MONTGOMERY COUNTY HISTORIC PRESERVATION COMMISSION
STAFF REPORT

Address:	5 Grafton Street, Chevy Chase	Meeting Date:	9/9/2020
Resource:	Contributing Resource (Chevy Chase Village Historic District)	Report Date:	9/2/2020
		Public Notice:	8/26/2020
Applicant:	Richard Perle & Leslie Barr Trust (Luke Olson, Architect)	Tax Credit:	N/A
Review:	HAWP	Staff:	Michael Kyne
Case Number:	35/13-20AA		
PROPOSAL:	Building addition and alterations

PROPOSED RIGHT SIDE ELEVATION

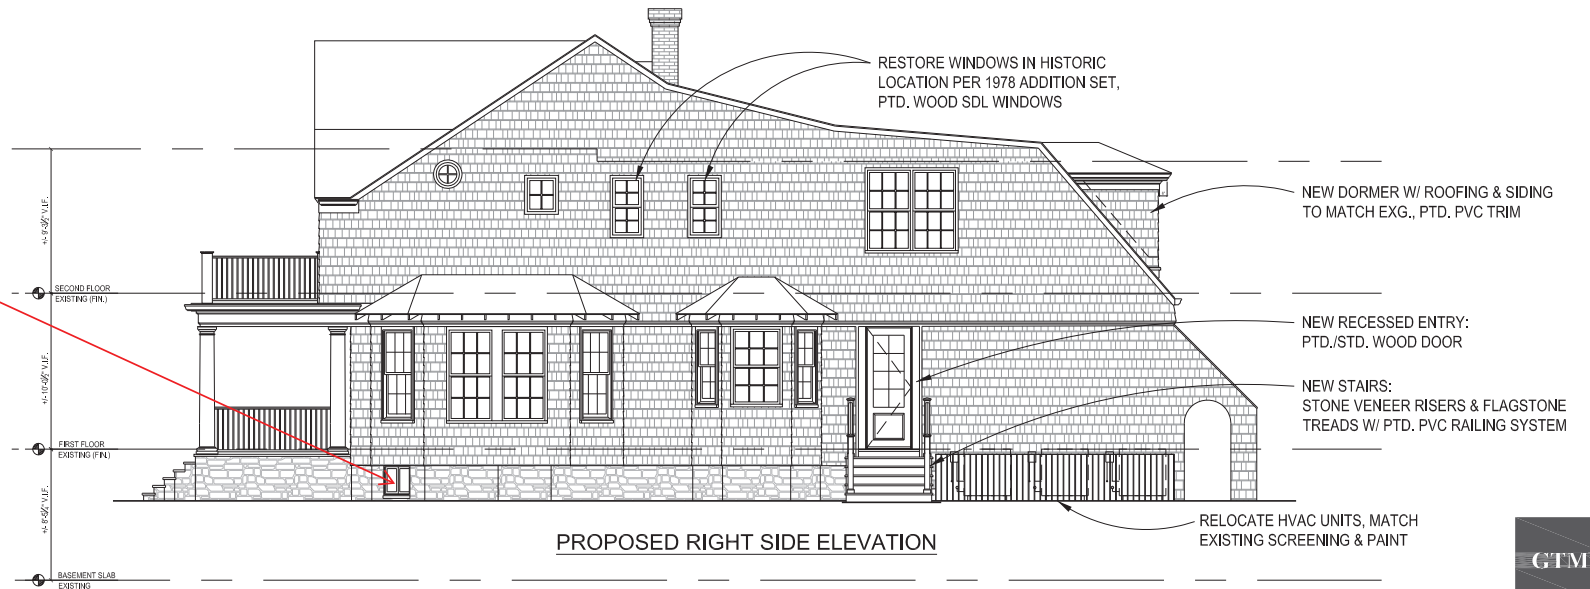
- Installation of a window well at the front of the frontmost bay on the east (right) elevation of the historic house for egress purposes.
 - Window well materials to include a stone veneer on the inside, a flagstone cap, a painted metal ladder mounted on the inside, and a painted metal grate on top for safety purposes.
- Replacement of the existing basement-level window at the front of the frontmost bay on the east (right) elevation of the historic house with an aluminum-clad SDL casement egress window.
 - The existing window width will be retained, but the window will extend down.

Staff supports the applicants' proposal, finding it consistent with the *Guidelines* and with the Commission's recommendations at the preliminary consultation. The proposed alterations will not remove or alter character defining features of the subject property, in accordance with *Standards* #2 and #9. In accordance with *Standard* #10, the alterations can be removed in the future without impairing the essential form and integrity of the historic property and its environment.
